## **Additional Technical Information**

**IEL Reg. No. P1069-01**

**William Connolly & Sons Unlimited  
Company**

**Title: Additional Technical Information, IEL Reg. No. P1069-01, William Connolly & Sons Unlimited Company, Grange Lower, Goresbridge, Co. Kilkenny**

**Figure 6-1: SW Monitoring Locations**

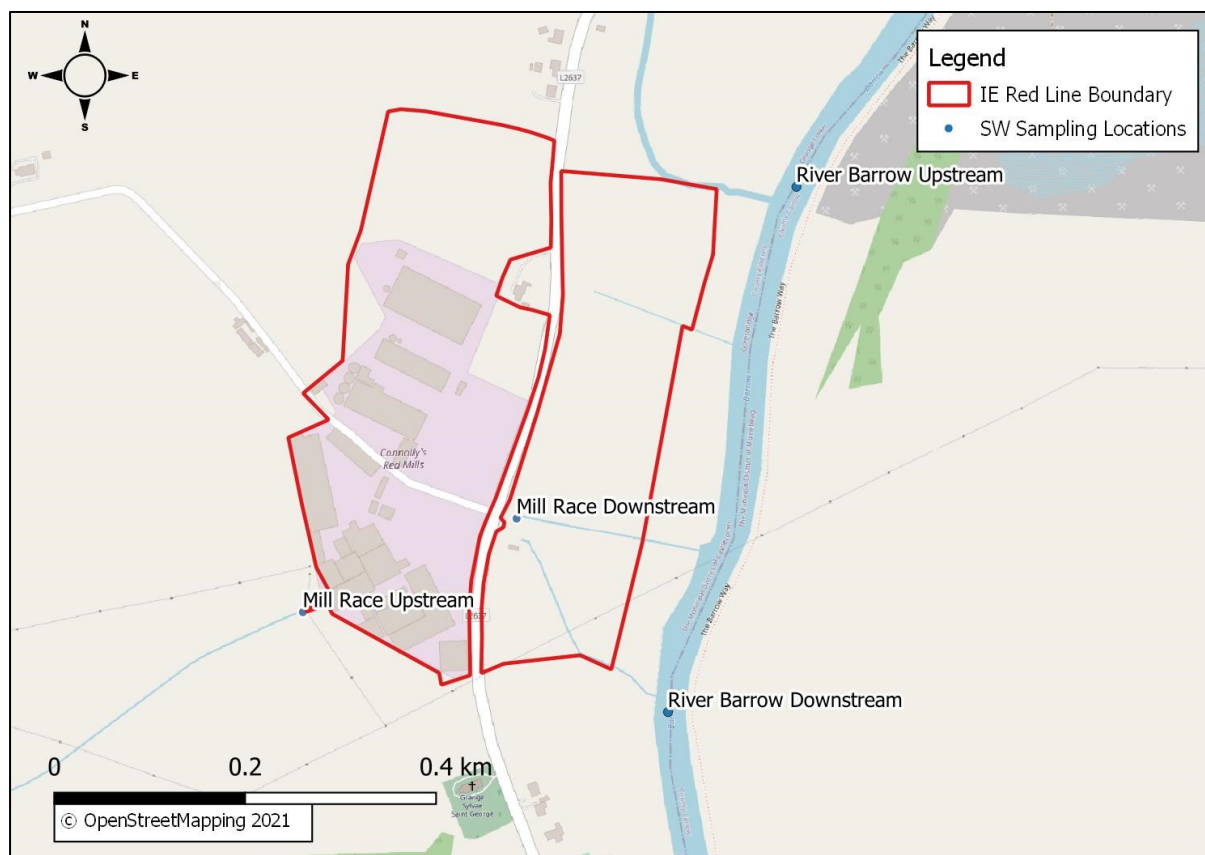
- h. Regarding the surface water laboratory reports, show monitoring locations on a drawing and clarify if they correspond with Locations 1-7 on drawing IE1540-001.

A number of the existing discharge locations, namely SW3, SW5 and SW6 could not be sampled as these locations could not be accessed in a safe manner. SW4, whilst somewhat accessible; requires a forklift to lift a metal grate in order to take grab sample, hence seeking to collect a sample from this location was not straightforward. Regardless no flow was observed from SW2, SW4 or the ICW inlet during any of the monitoring events; samples were therefore not collected by MOR personnel from these locations.

In the absence of being able to collect direct surface waters samples, MOR focused on collecting samples from the receiving waters to determine whether stormwater emissions arising from the Site were having any impact on the receiving environment. In order to evaluate a worst-case scenario three separate monthly samples were collected during peak harvest season i.e. July, August and September 2021 at representative locations both upstream and down of discharge points on the receiving Mill Race and the River Barrow. Please see Figure 6-1 below which identifies the monitoring locations.

As can be clearly determined based on a review of Figure 8-1, the monitoring locations were selected to target areas immediately up and downgradient of the Site. In keeping with the robust assessment that was undertaken by MOR the downgradient sample location on the River Barrow was immediately down gradient of the confluence of the River Barrow and a field drain that bisects Red Mills lands, that is in proximity to the wastewater treatment facility that serves the facility. This location was selected to determine whether any potential impacts could be arising from this treatment facility. Hence this just reaffirms the overall objective of presenting a robust scientific data set to the Agency
